Access Compliance Report Public Rights-of-Way (Curb Ramps)

Intersection ID: 12265 Main Street: S CHURCH ST Cross Street: W_4TH_ST Location:

ADA ID: 9EC0C0E464AD Ramp Type: PerpDiag Initial Pass/Fail: Fail **Overall Compliance: No** Severity Score: 21.25

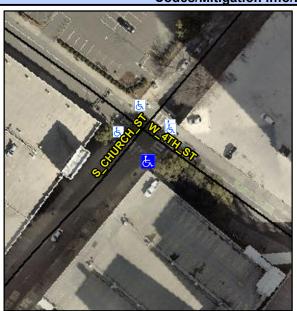
W 4TH ST Signal **S CHURCH ST** Signal Possible Solutions: Remove & Replace Curb Ramp With Two New Directional Ramps or Equivalent. Surveyor Notes: N/A PROW/ADA: Not Found, R304.5.1, R304.2.2

ried measurements/component compnance						
Compliance Description		Data	Compliance Description		Data	
N/A	Ramp Length (in)	70.0	No	Ramp Slope (%)	10.6	
No	Ramp Width (in)	39.0	Yes	Ramp XSlope (%)	0.2	
N/A	Flare Type LT	N/A	N/A	Flare Type RT	N/A	
N/A	Flare Slope LT (%)	N/A	N/A	Flare Slope RT (%)	N/A	
N/A	Flare Traversable LT?	N/A	N/A	Flare Traversable RT?	N/A	
N/A	Landing Length (in)	N/A	N/A	DWS Provided?	N/A	
N/A	Landing Width (in)	N/A	N/A	DWS Contrast?	N/A	
N/A	Landing Slope (%)	N/A	N/A	DWS Length (in)	N/A	
N/A	Landing X Slope (%)	N/A	N/A	DWS Full Width?	N/A	
N/A	Landing Curb? (Y/N)	N/A	N/A	DWS Offset (in)	N/A	
N/A	Shared Landing?	N/A				
N/A	Gutter Ponding?	N/A	N/A	Gutter Slope (%)	N/A	
N/A	Gutter Lip Ht (in)	N/A	N/A	Gutter X Slope (%)	N/A	
N/A	Painted X Walk1?	Yes	N/A	Painted X Walk2?	Yes	
	X Walk 1 Direction	To NE		X Walk 2 Direction	To NW	
N/A	X Walk 1 Width (in)	114.0	N/A	X Walk 2 Width (in)	113.0
